Informal document No. GRSP-49-06
(49th GRSP, 16-20 May 2011
agenda item 9.)

Proposal for amendments to ECE Regulation No. 14
(Safety-belt anchorages)

The following document transmitted by OICA contains a first draft proposal to amend ECE Regulation No. 14, in order to take into account the development of a new ECE Regulation on Child Restraint Systems. This proposal is aimed at ensuring compatibility between vehicles and the child restraint systems complying with the new draft Regulation.

i-Size draft v 8.0, OICA, 04.05.2011

Figure 1: 3D view of the support leg foot assessment volume

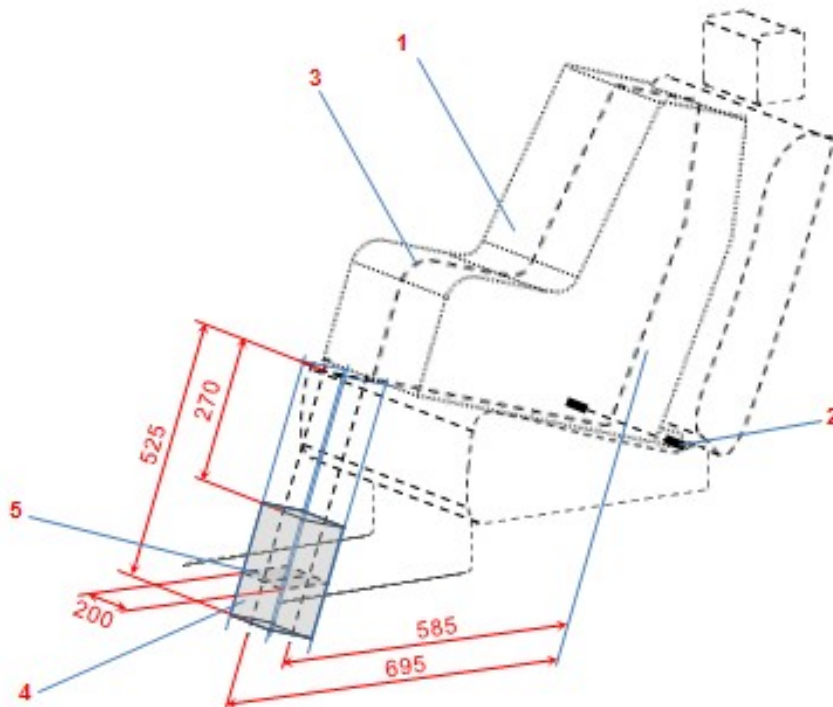
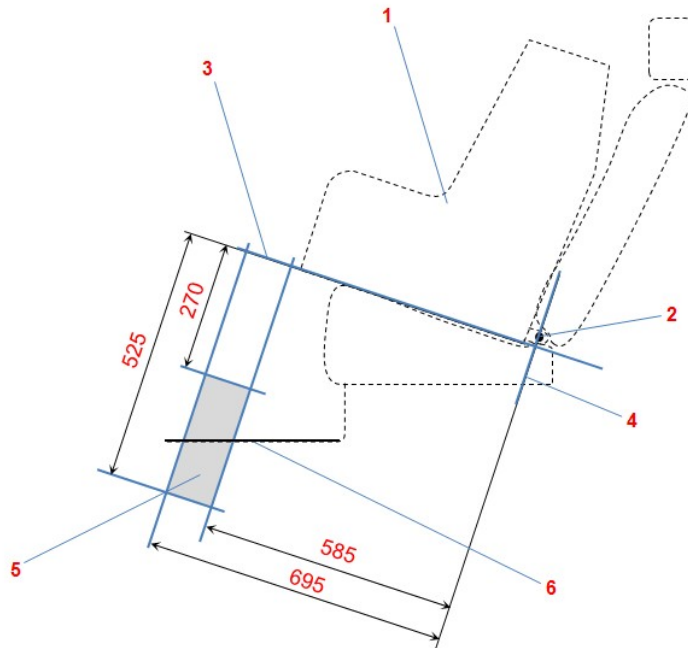
In addition to the requirements defined in 5.2.3. and 5.2.4. it shall be verified that the upper surface of the vehicle floor (incl. trim, carpet, foam, etc.) is intersecting with both limiting surfaces in x- and y-direction of the support leg foot assessment volume, as shown in figure 1 and 2 of annex 10 of this Regulation.

The support leg foot assessment volume is characterized as follows (see also annex 10, figure 1 and 2 of this Regulation):

- In width by two planes parallel to and 100mm apart from the median longitudinal plane of the child restraint fixture installed in the respective seating position; and
- In length by two planes perpendicular to the plane given by the child restraint fixture bottom surface and perpendicular to the median longitudinal plane of the child restraint fixture, 585mm and 695mm apart from the plane passing through the centerlines of the ISOFIX lower anchorages and being perpendicular to the CRF bottom surface; and
- In height by two planes which are parallel to and 270mm and 525mm below the child restraint bottom surface.

Figure 2: Side view of the support leg foot assessment volume

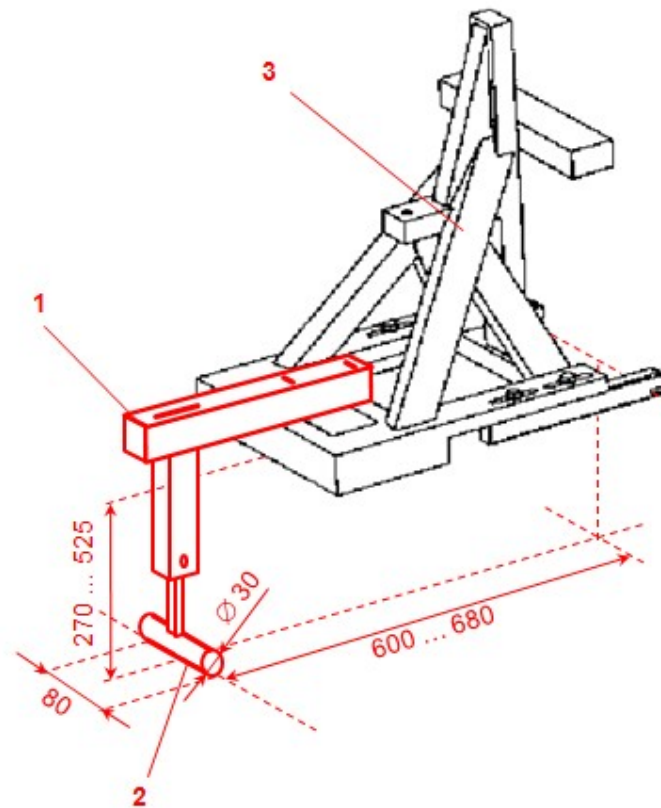
In addition to the test[s] specified in [6.6.4.3. and] 6.6.4.4. a test with a modified static force application device, which consists of an SFAD and includes a support leg test probe as defined in figure 3 of annex 10, shall be performed. The support leg test device shall be adjusted in length and width to assess the vehicle floor contact surface, as defined in paragraph 5.2.5.2. (see also figure 1 and 2 of annex 10 of this Regulation). The height of the support leg test device shall be adjusted in the way that the foot of the support leg test device is in contact with the upper surface of the vehicle floor. In case of incremental height adjustment the first notch where the foot rests stable on the floor shall be chosen, in case of a non-incremental/continuous adjustment of the support leg test device height the pitch angle of the SFAD shall be increased by [1.5 +/- 0.5 degrees] due to the height adjustment of the support leg test device.
